Norfolk Boreas Offshore Wind Farm Applicant's comments on Written Representations and Additional Submissions

Applicant: Norfolk Boreas Limited
Document Reference: ExA.WRR.D3.V1
Deadline 3

Date: December 2019
Revision: Version 1
Author: Royal HaskoningDHV

Figure 2 - Viewpoint
3: Lodge Lane North

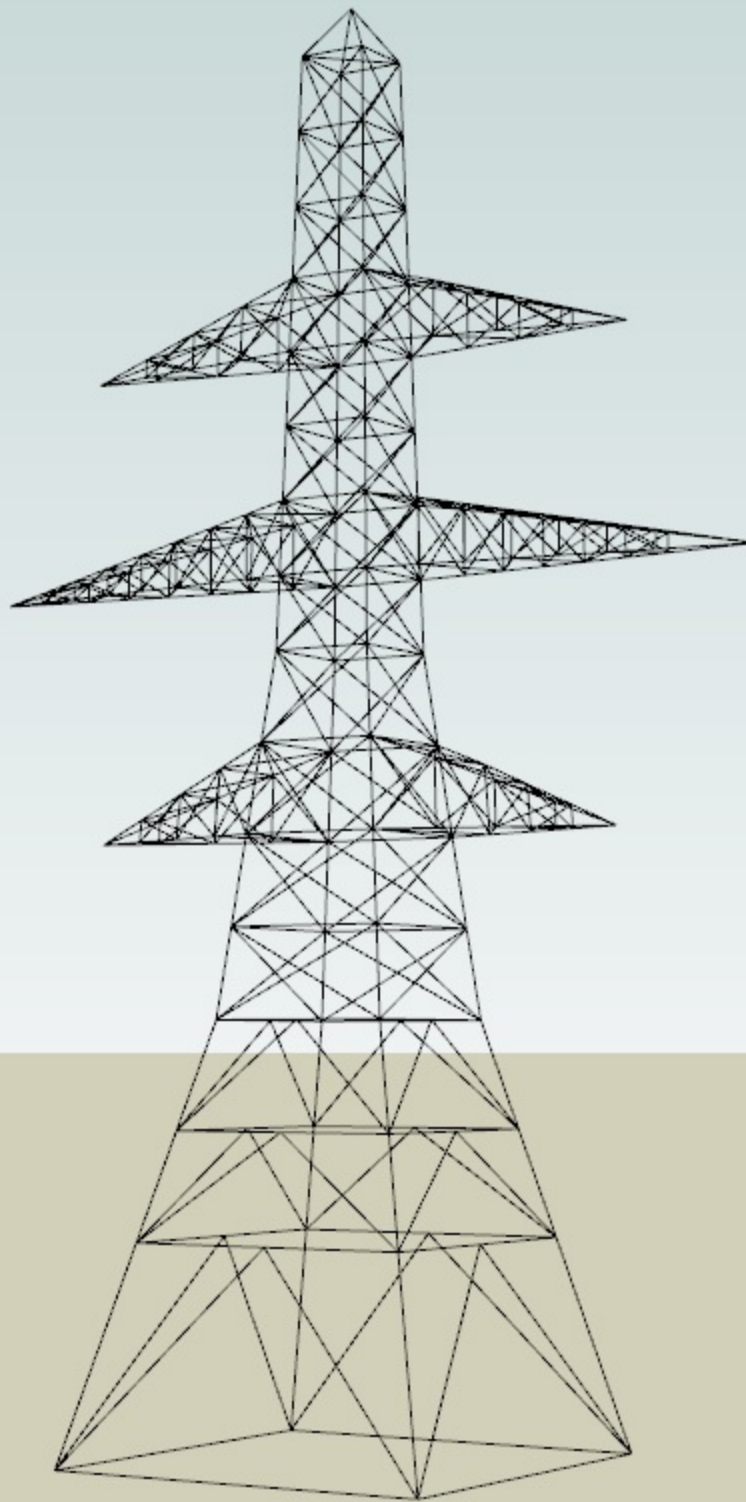
Summary of Written Representation	Applicant's Response
REP2-105 requests that the Applicant provides a photomontage showing the appearance and position of the new pylon at the National Grid substation extension in relation to existing overhead pylons.	The Landscape and Visual Impact Assessment (LVIA) visualisations presented in the Environment Statement (ES Figures 29.23 to 29.46 (APP-509 to APP-532) include the overhead line modifications (required under Scenario 2) as well as the National Grid substation extension and the onshore project substation. The Applicant has included three images at Appendix 1 to illustrate the proposed changes to the overhead electricity transmission line adjacent to the National Grid substation extension. The first image (Figure 1) shows the model of the tower that was used in the production of the LVIA visualisations. This model was selected as it best matched the dimensions of the proposed towers. The second image (Figure 2) is a zoomed in extract from Viewpoint 3: Lodge Lane North, showing the baseline view - that is the view without the addition of the project. The third image (Figure 3) is a zoomed in extract from the visualisation produced for Viewpoint 3: Lodge Lane North for Scenario 1 (ES Figure 29.25, APP-511), Scenario 1 is the worst case as it includes the National Grid substation extensions required for Norfolk Boreas and Norfolk Vanguard, as well as the

2. The figures illustrate the proposed changes to the overhead electricity transmission line adjacent to the National Grid substation extension.
3. Figure 1 shows the model of the tower that was used in the production of the Landscape and Visual Impact Assessment visualisations (presented in the Environment Statement (ES) Figures 29.23 to 29.46 (APP-509 to APP-532)). This model was selected as it best matched the dimensions of the proposed towers.

4. Figure 2 is a zoomed in extract from Viewpoint 3: Lodge Lane North, showing the baseline view - that is the view without the addition of the project.

5. Figure 3 is a zoomed in extract from the visualisation produced for Viewpoint 3: Lodge Lane North for Scenario 1 (ES Figure 29.25, APP-511), Scenario 1 is the worst case as it includes the National Grid substation extensions required for Norfolk Boreas and Norfolk Vanguard, as well as the proposed changes to the overhead electricity transmission line (which under Scenario 1 would have been undertaken by Norfolk Vanguard).

6. It is important to note that while these present an accurate representation of the size and scale of the new tower and replaced tower, the final detailed appearance of the tower is yet to be confirmed.
